EPEE and Eurovent would like to thank you for giving us the opportunity to provide comments on the Working Documents on air heating products, cooling products and high temperature process chillers (Ecodesign ENTR Lot 6/ENER Lot 21 and parts of ENTR Lot 1).

**EPEE and Eurovent Position on the working documents on requirements for air heating products, cooling products and high temperature process chillers**

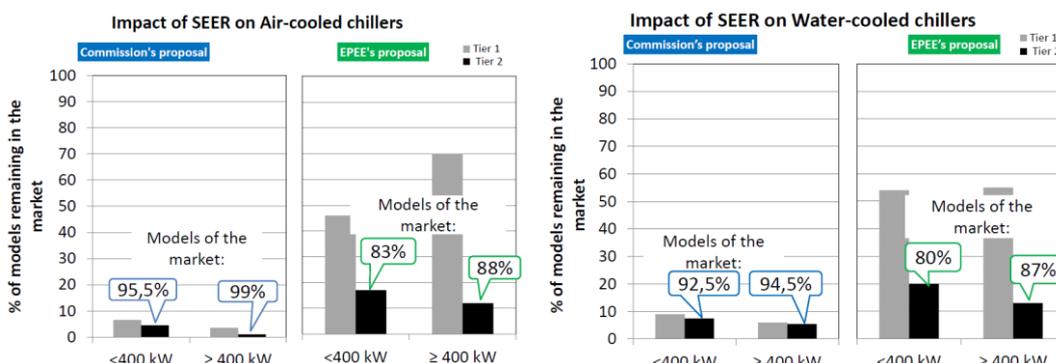
- Moreover, the proposed requirements need to balance differences in the operation chillers in cooling and heating systems. Due to the reversibility of some chillers, improving the cooling function does not necessarily result in improving the heating function and vice versa. Since the heating requirements have been decided under another Ecodesign implementing

measure, the cooling requirements should take these into account in order to allow for a feasible balancing of cooling and heating efficiency.

- Regarding the timing, EPEE considers that the proposal to introduce different implementation timeframes for Lot 1 ((EU) No 813/2013) and Lot 6/Lot 21 creates complexity and provides industry with too many different targets to achieve.

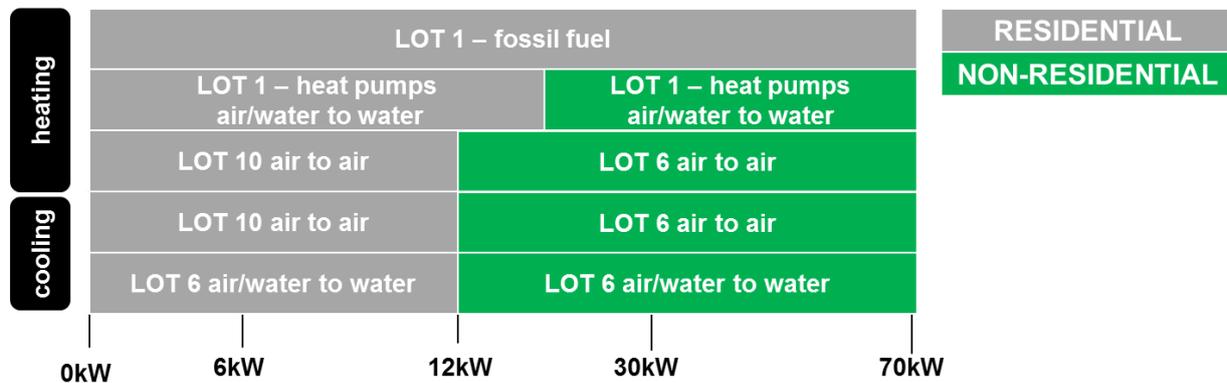
In our view, the sound power requirements for air-to-air air conditioners and heat pumps are based on the assumption that the outdoor units of the air-to-air air conditioners and heat pumps are the same as the outdoor units of the ENER Lot 1 products. In other words, the sound power requirements are based on the base case of the ENER Lot 1 products. Indeed some outdoor unit types of ENER Lot 1 have similar technologies, but do not necessarily possess the same sound power levels. ENTR Lot 6 base cases have higher energy efficiencies and sound powers than ENER Lot 1 products. More efficient products require higher air flows in the equipment, which consequently causes relatively more noise. Meeting the sound power requirements is therefore not feasible.

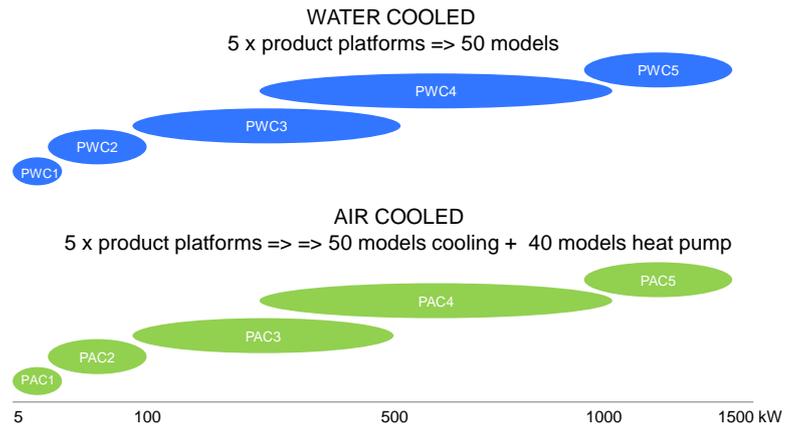
For all these reasons, there is very little room for efficiency improvement in the future for this category of machines, already highly optimized. One possibility would be to use magnetic bearing centrifugal compressors. They can offer a better efficiency than screws at part load. But these machines are still quite expensive. Also, in the capacity range that is needed for this category of chillers, these compressors are offered by only one manufacturer. Setting MEPS targets that can be reached with this technology only would create a monopoly situation that is not acceptable.

As a conclusion, we believe that the best machines available today in this category (air cooled >400 kW) are already close to an optimum. It would be unrealistic to expect further substantial improvements in the mid-term future.
